VENKATESHWAR HOSPITAL

BUNKER LAYOUT- LOWER BASEMENT

VH/DW/BRK 1

REVISION/ REMARKS NO 1 : 12.09.14

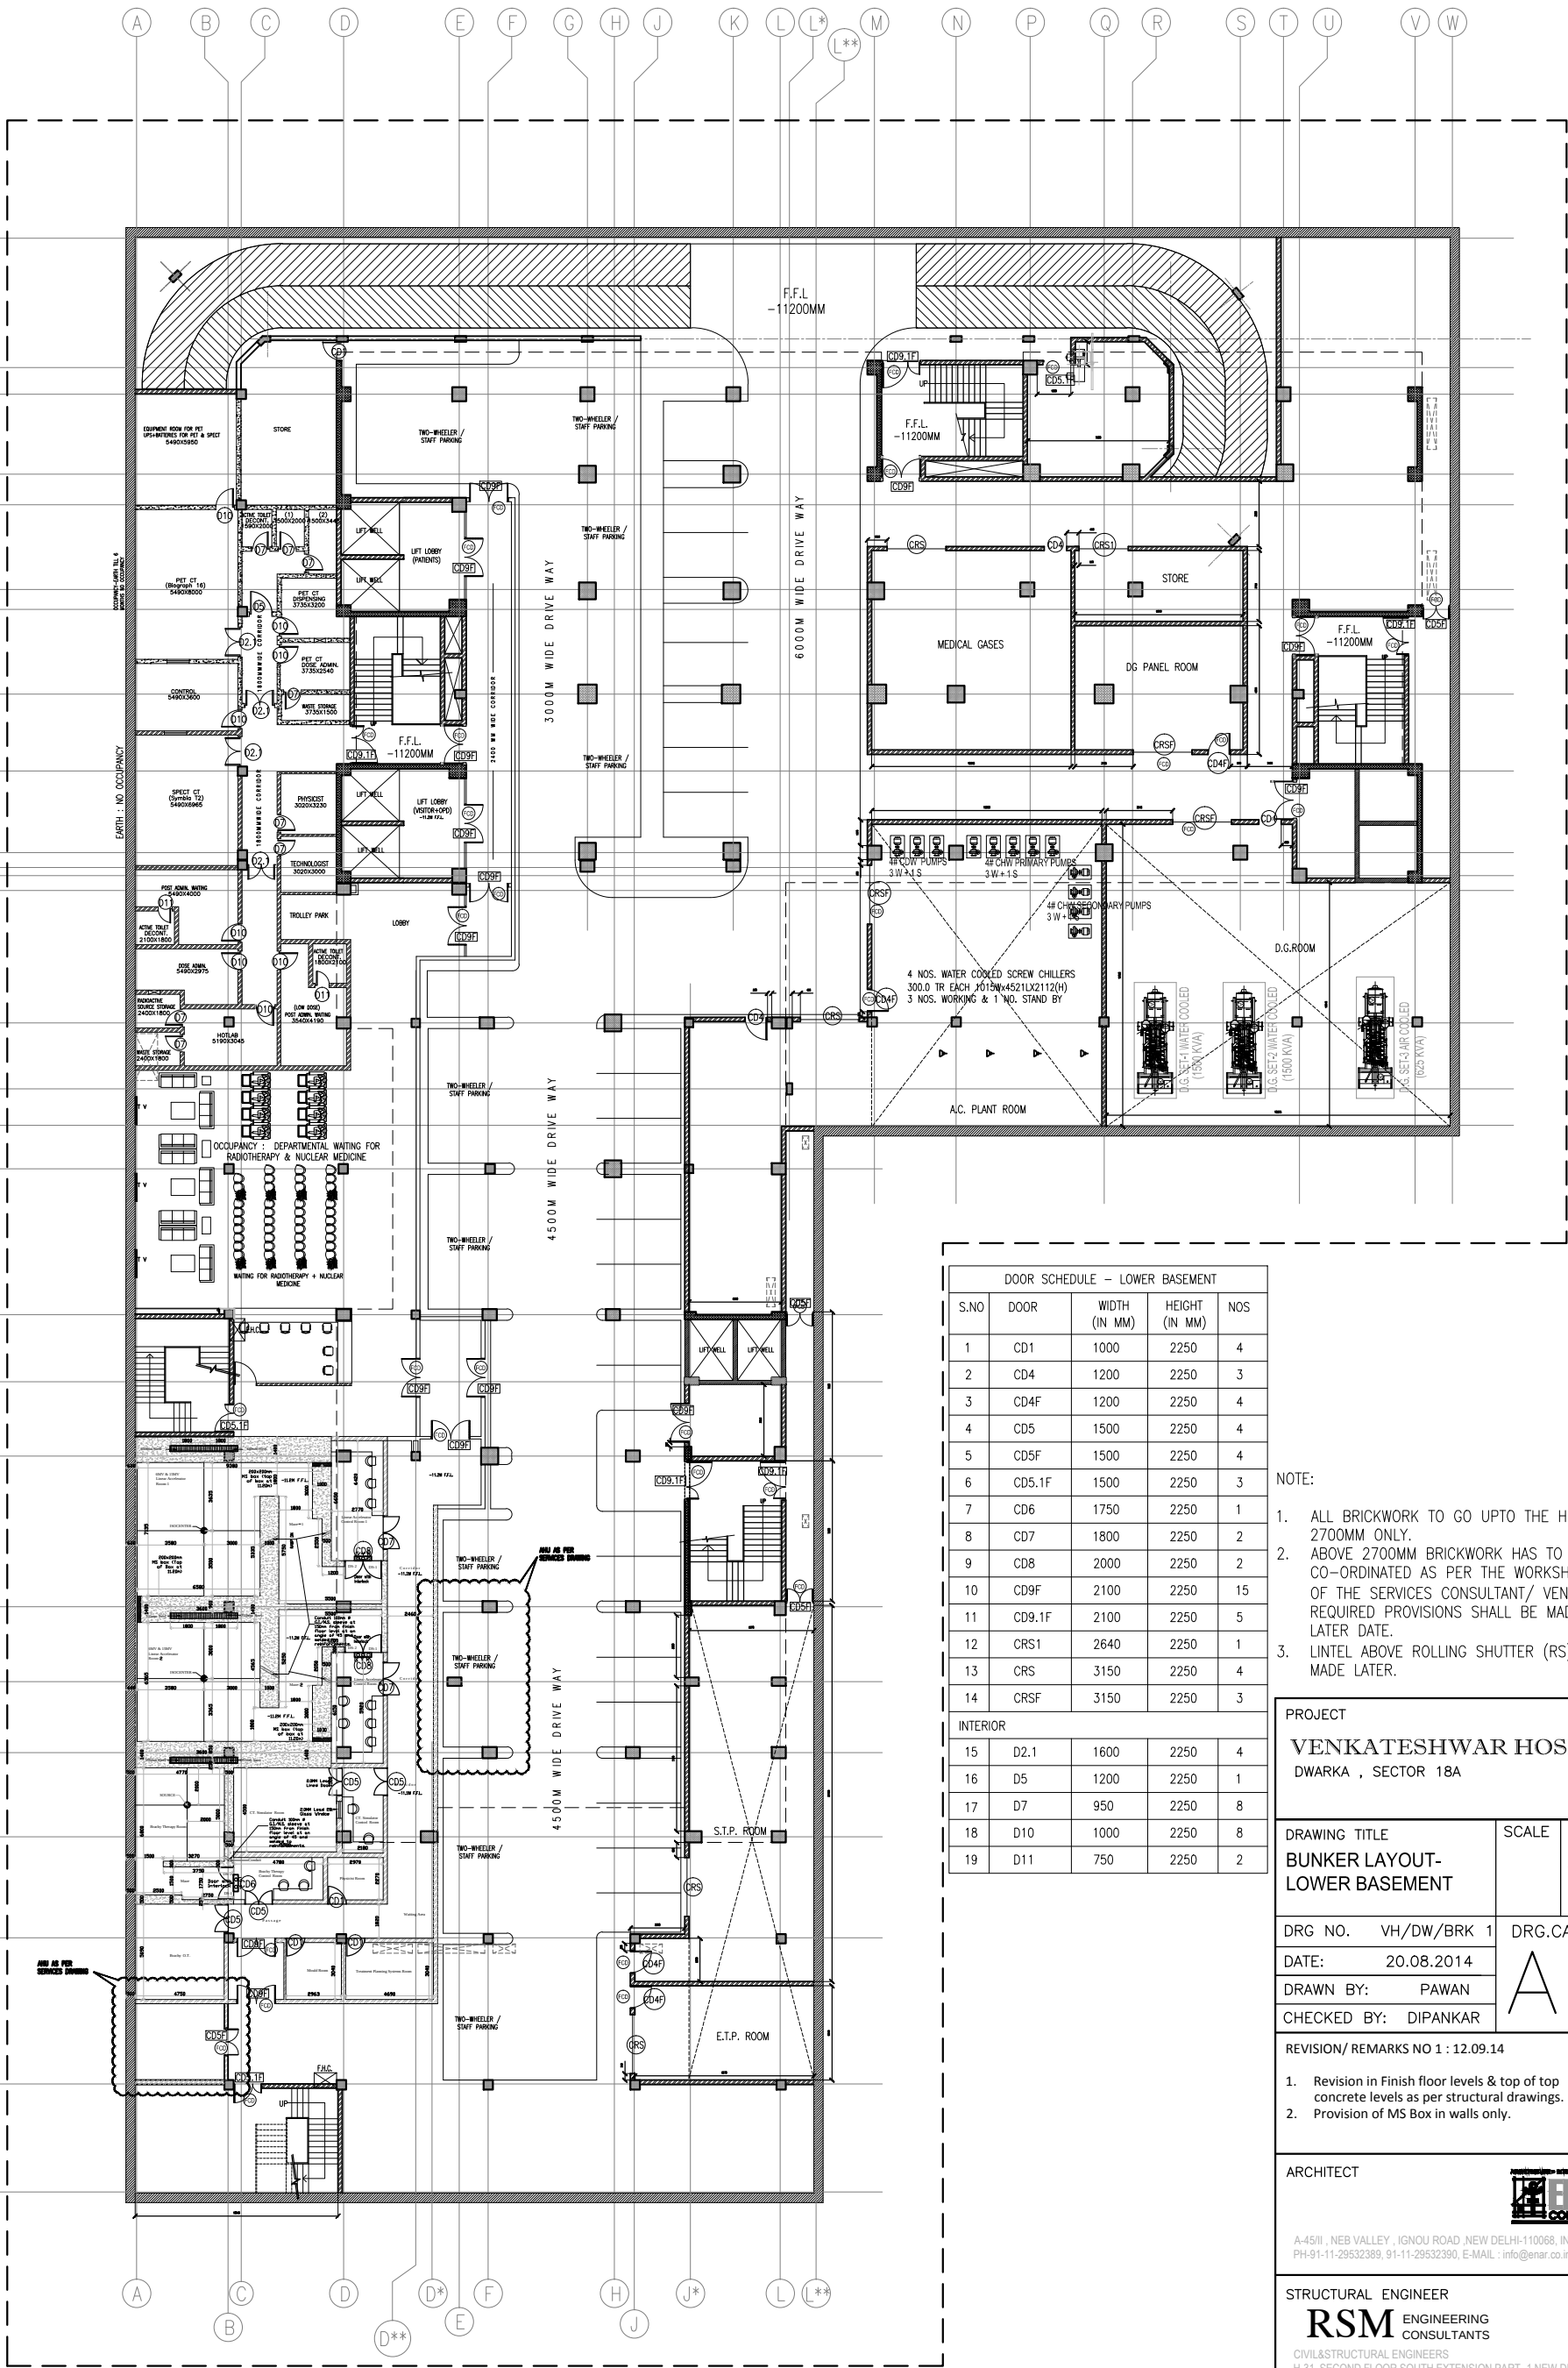
1. Revision in Finish floor levels & top of top concrete levels as per structural drawings.

2. Provision of MS Box in walls only.

DRAWING TITLE FOURTH FLOOR	SCALE
--------------------------------------	-----------

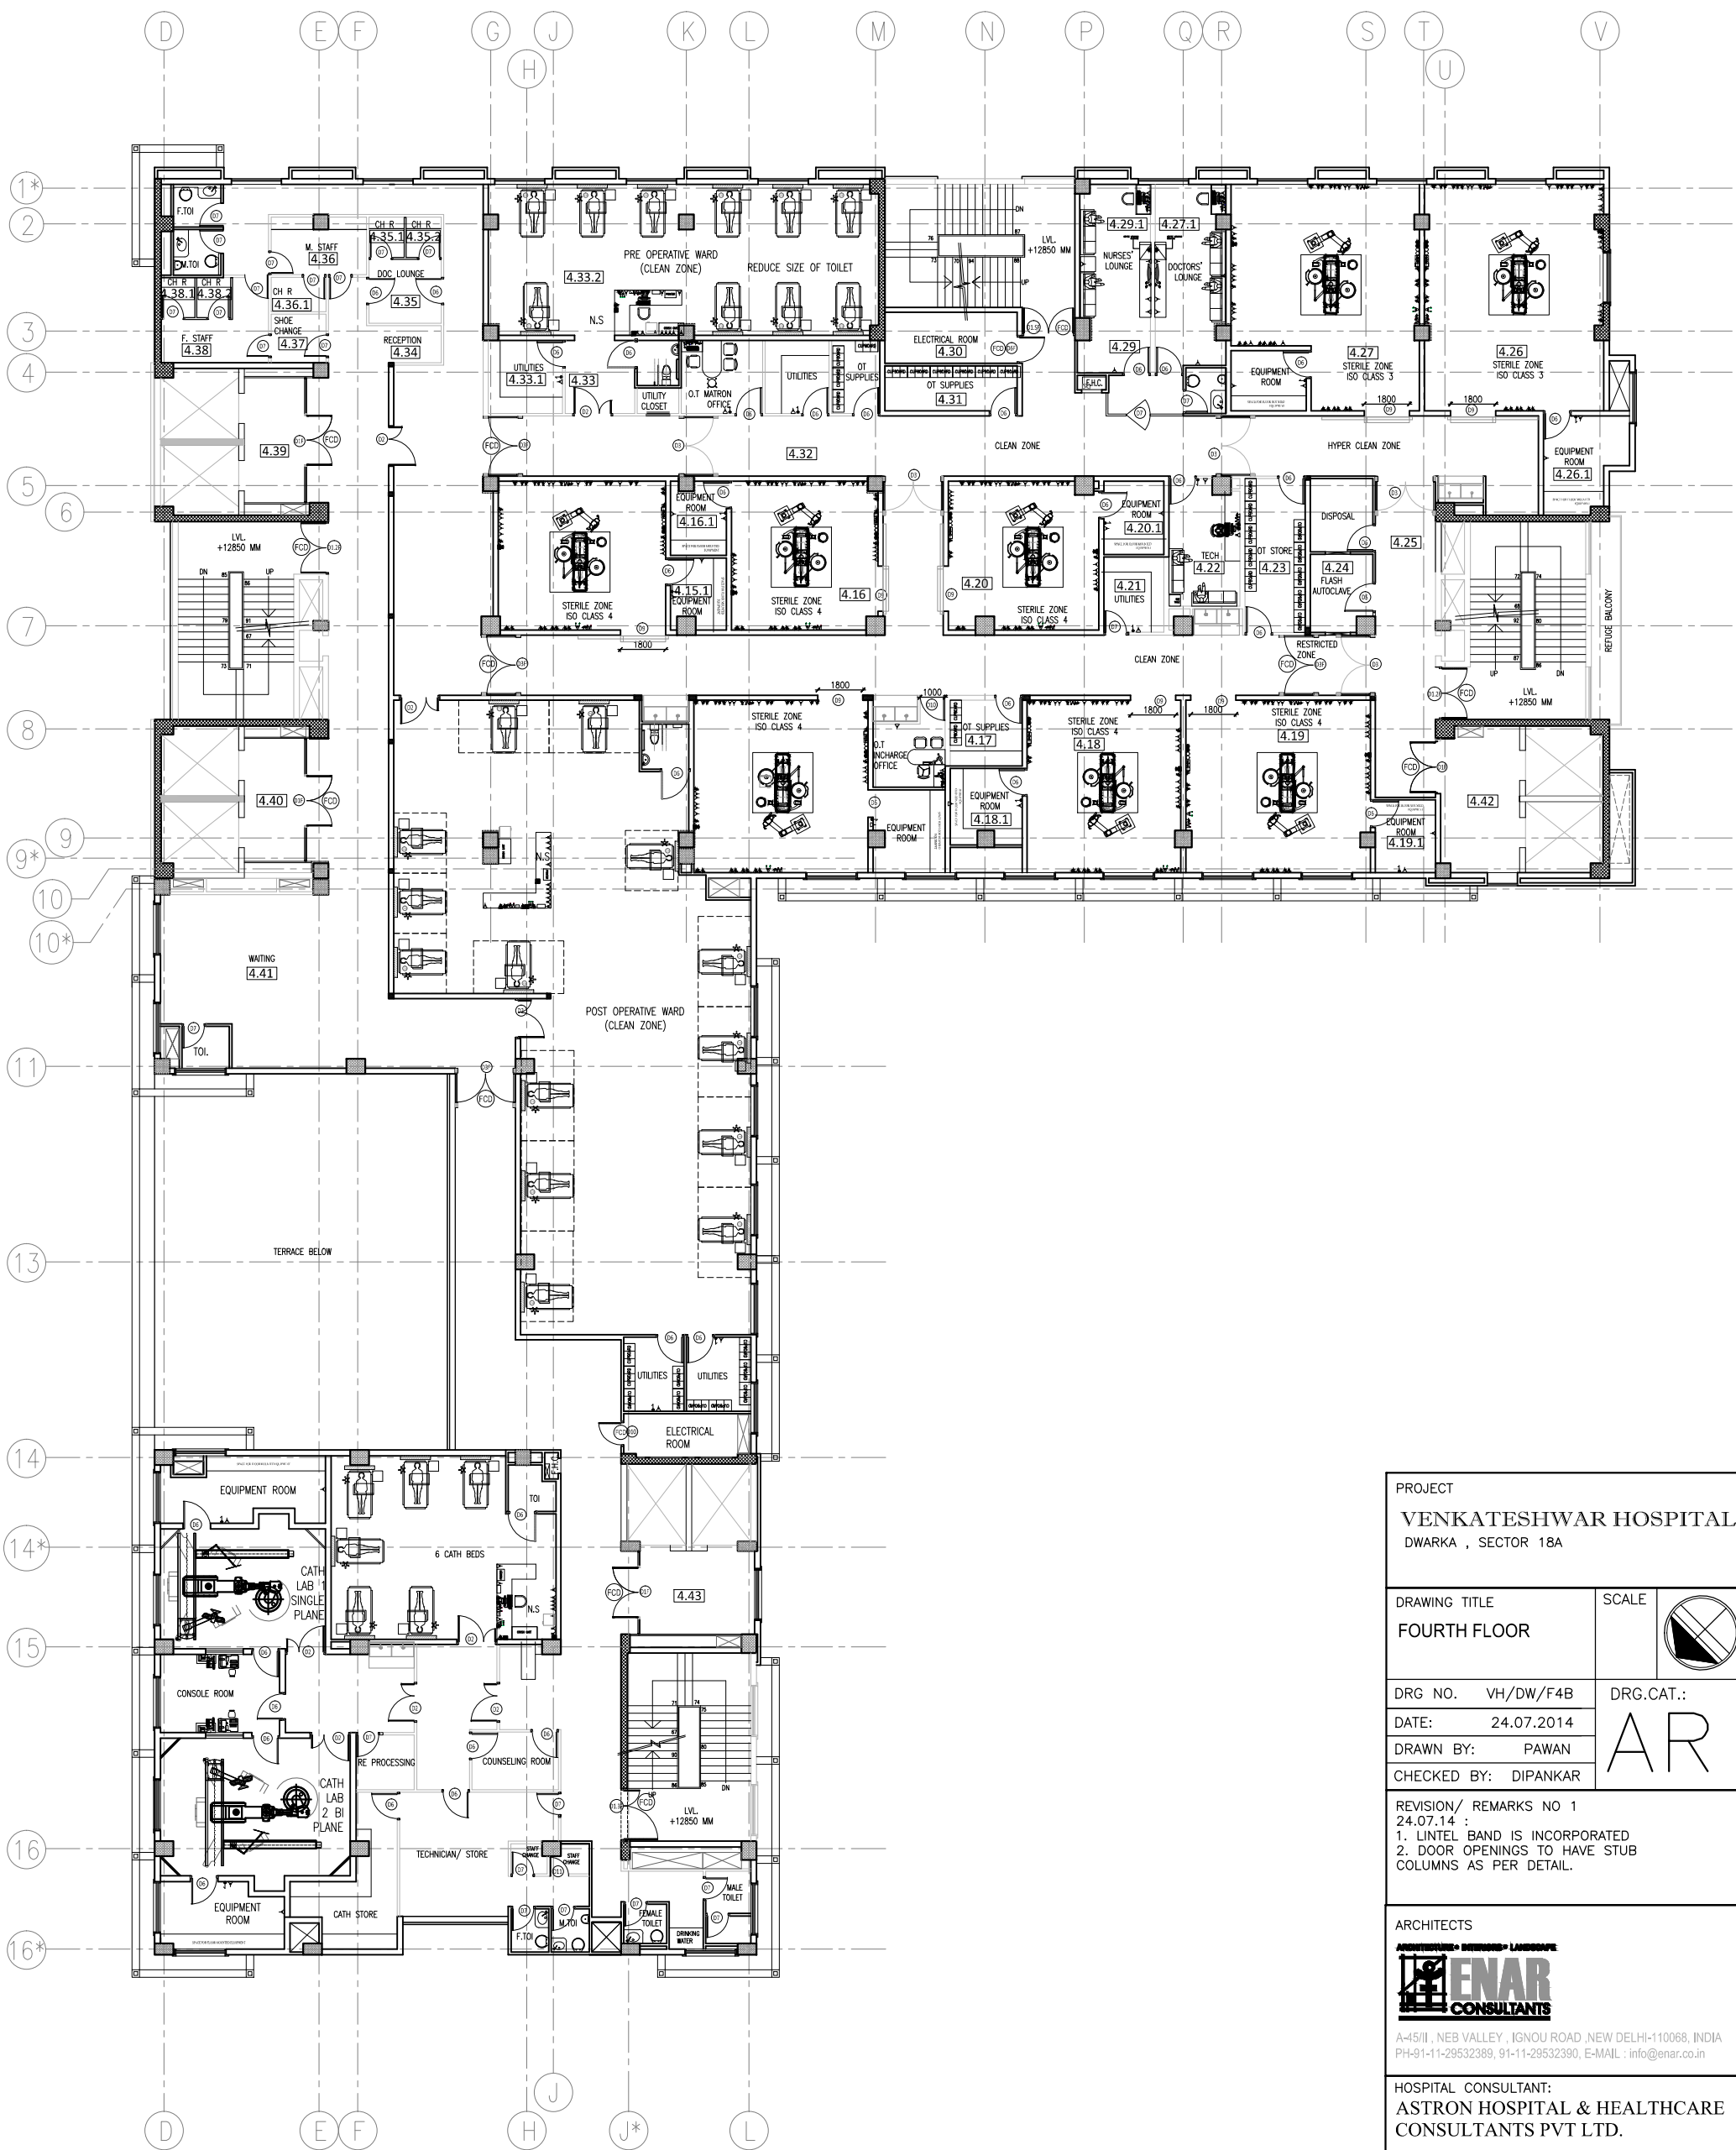
REVISION/ REMARKS NO 1
24.07.14 :
1. LINTEL BAND IS INCORPORATED
2. DOOR OPENINGS TO HAVE STUB
COLUMNS AS PER DETAIL.
